**CITY COUNCIL MEETING STAFF REPORT**

**DATE OF MEETING:** March 19, 2024  
**NAME OF PROJECT:** Ameyalli  
**NAME OF APPLICANT:** Midway Mountain Spa, LLC  
**AUTHORIZED REPRESENTATIVE:** Chuck Heath  
**AGENDA ITEM:** Amendment to the Ameyalli Master Plan Amendment  
**LOCATION OF ITEM:** 900 North Wellness Drive  
**ZONING DESIGNATION:** RZ

Chuck Heath, representative for Midway Mountain Spa LLC, has submitted a Master Plan Amendment for the Ameyalli Resort on 28.87-acres. The proposed Master Plan Amendment would amend the Master Plan Agreement to reduce the approved required parking, remove a private road from the plans, and reduce the number of phases in the development from four to two. The property is located at approximately 800 North 200 East in the Resort Zone.

PHASE 2 PLANNING COMMISSION PRELIMINARY APPROVAL PACKAGE | FEBRUARY 2024

PHASE 2: AMEYALLI WELLBEING CENTER - 3D VIEWS - PREVIOUS

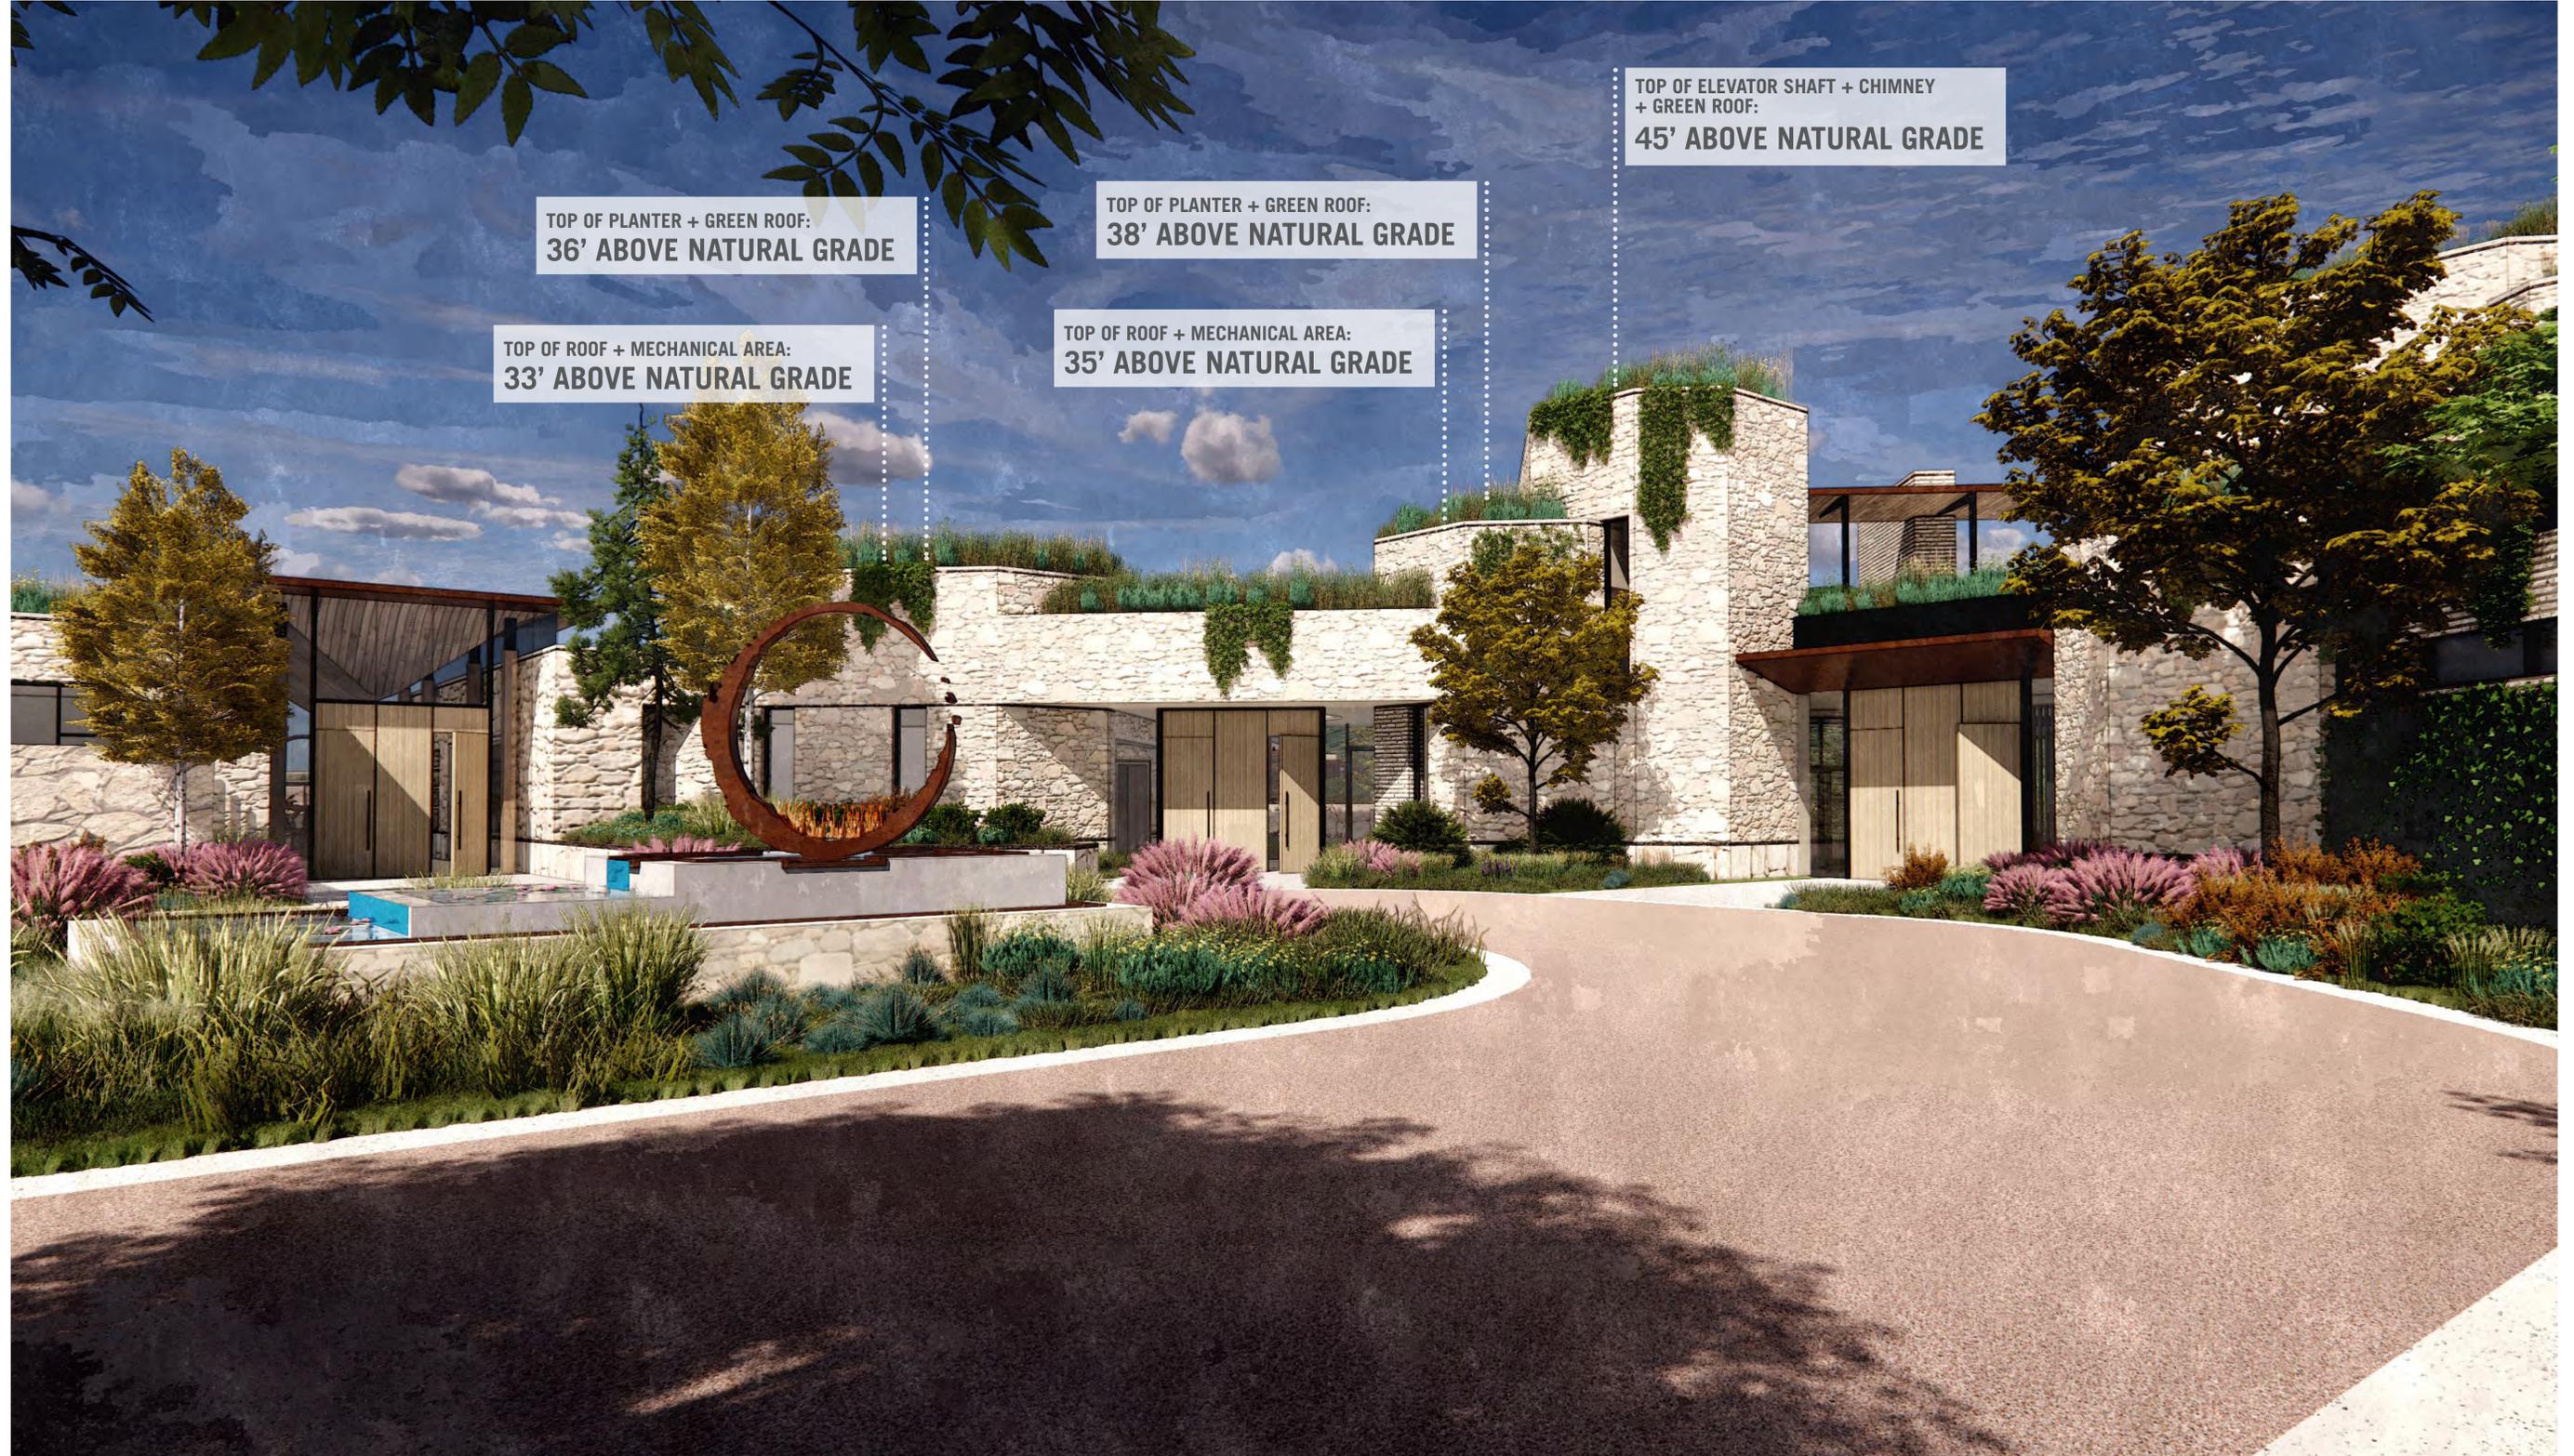
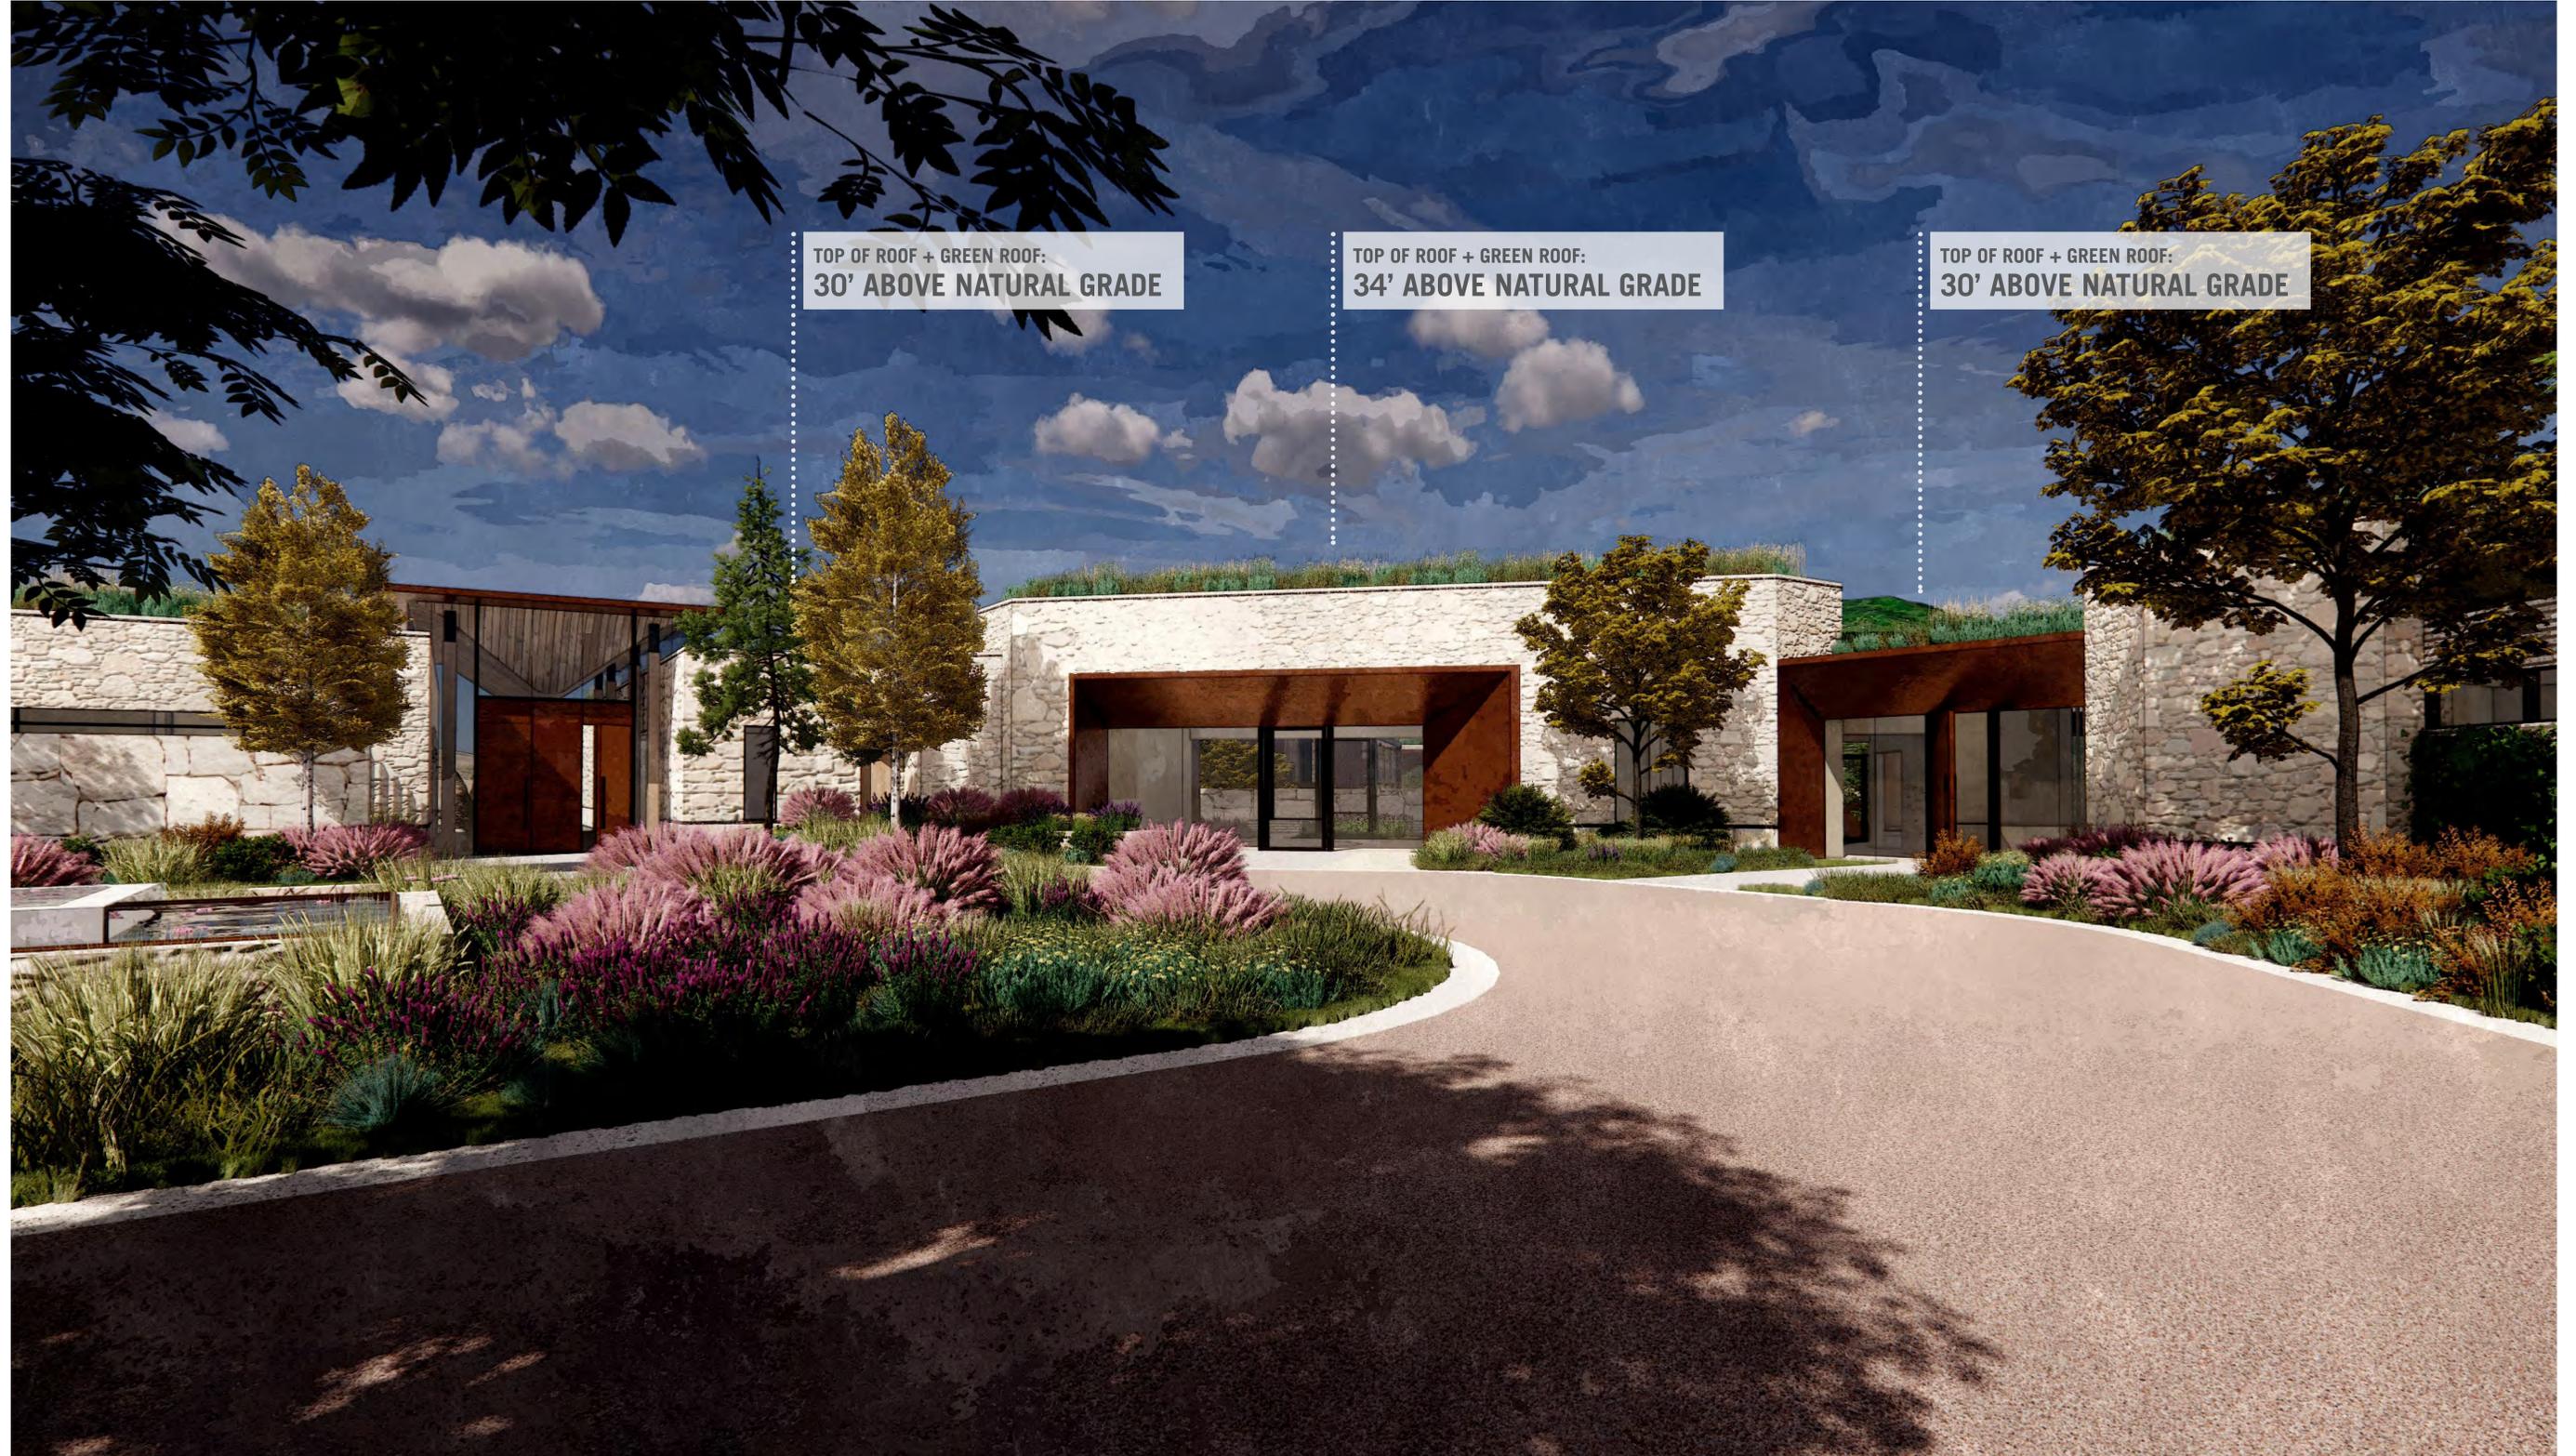
PHASE 2: AMEYALLI WELLBEING CENTER - 3D VIEWS - CURRENT
